Notice of Decision

Tentative Partition Plat, Site Plan Review for Tree Felling, and Site Plan Review for New Construction

PA-05-24; SP-08-24; & SP-09-24

May 28, 2024

TENTATIVE PLAT
 TENTATIVE PARTITION
 MAP 11S-3W-8CC
 TAX LOT 900
 ALBANY, OREGON

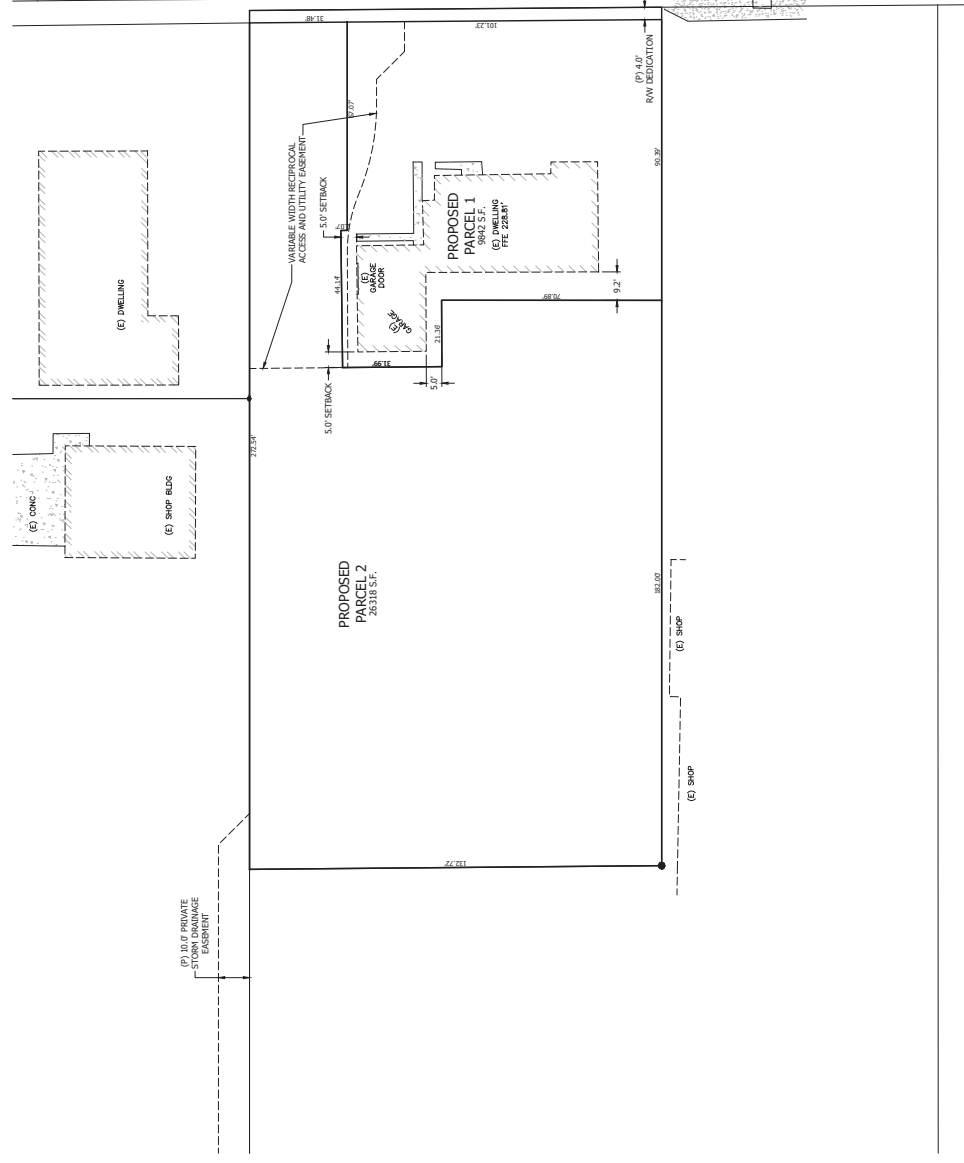
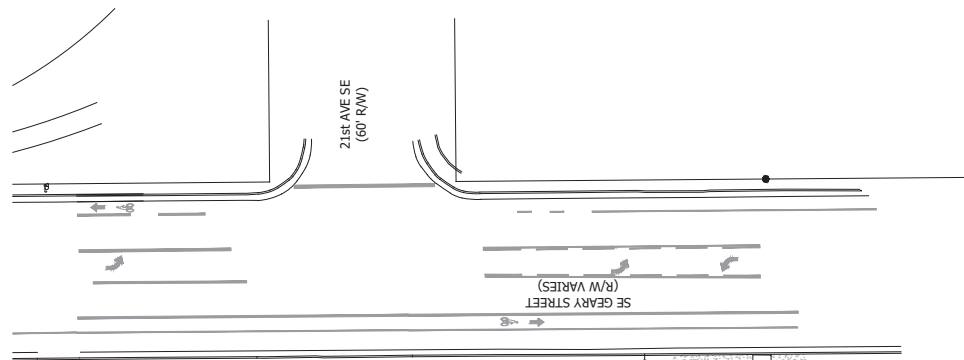
- Condition 1** Prior to recording the partition plat, the applicant shall:
- Dedicate four feet of public right-of-way along the site's frontage on Geary Street.

- Construct, or financially assure the construction of, public sidewalk to city standards along the frontage of the site on Geary Street.
 - Install a new driveway approach at the location shown on the approved tentative partition plat map, and pave or provide financial assurance for pavement of the shared portion of the driveway serving Parcels 1 and 2.

ENLARGED CIVIL SITE PLAN
 TENTATIVE PARTITION
 MAP 113-3W-8CC
 TAX LOT 900
 ALBANY, OREGON

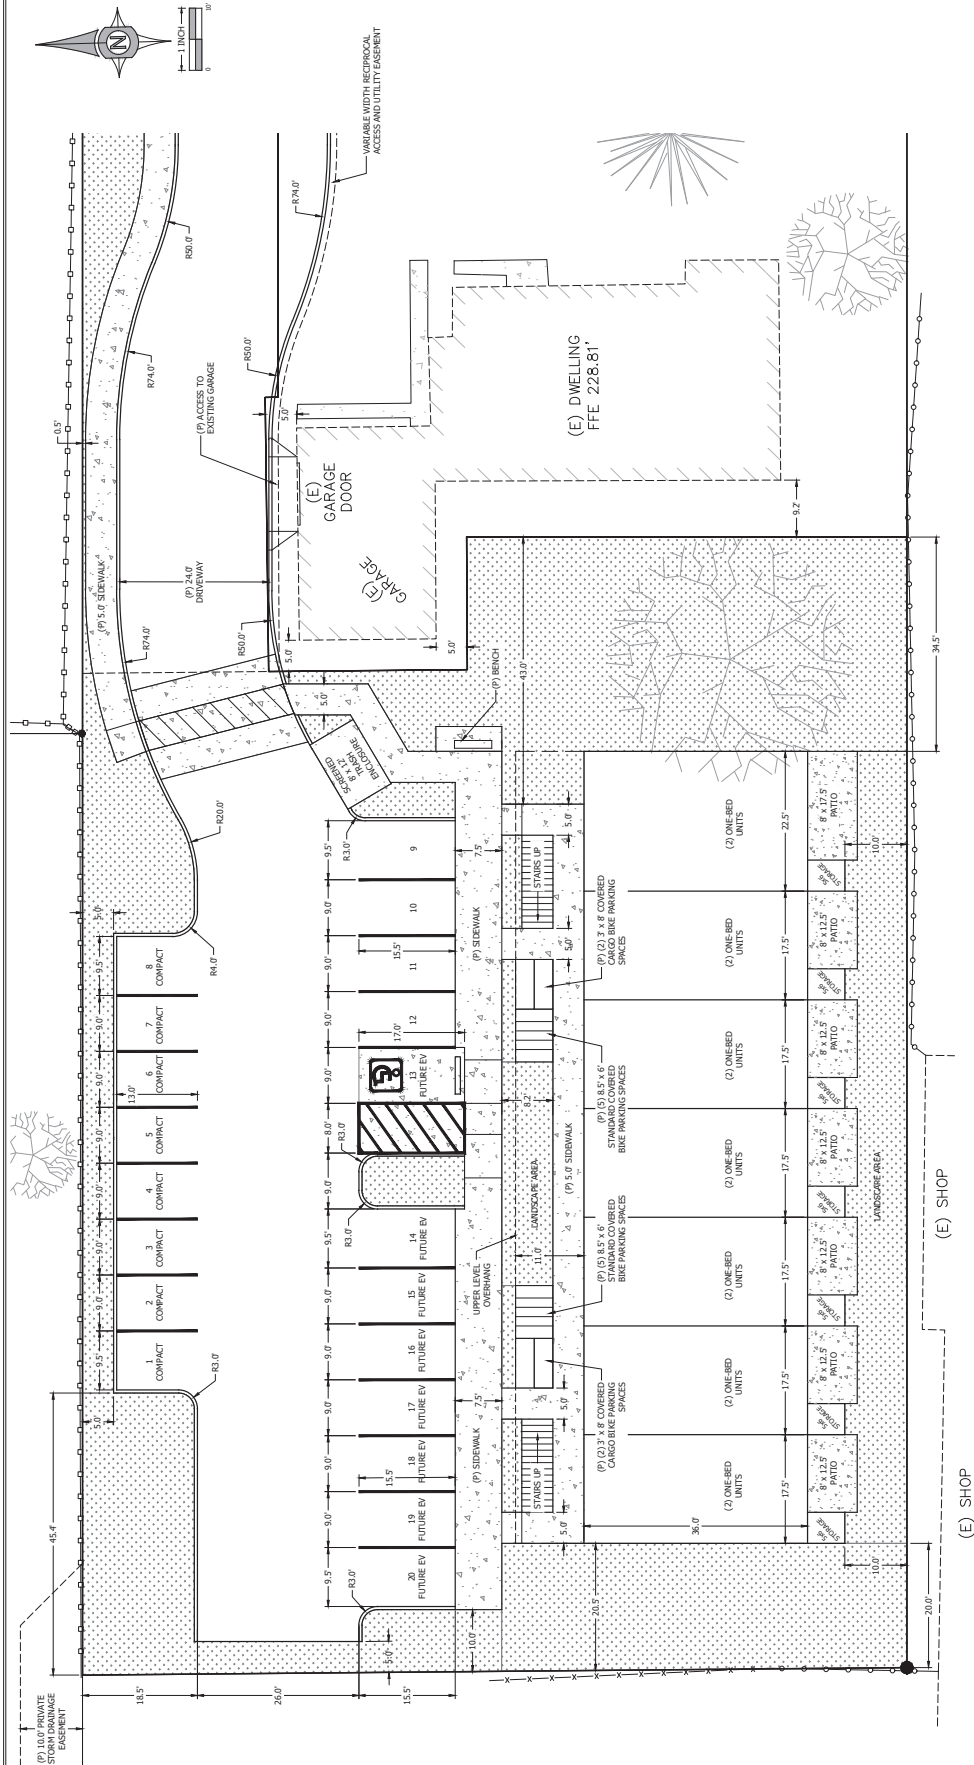
- Condition 11** **Carpool/Vanpool Parking.** Before the City will accept any building permits, the applicant shall submit an updated parking plan showing one standard-sized parking spot as reserved for carpool/vanpool.

Condition 12 Bicycle Parking. Prior to the acceptance of building permits, the applicant shall submit a bicycle parking plan showing dimensions and spaces meeting the standards in Table 9.030-2.
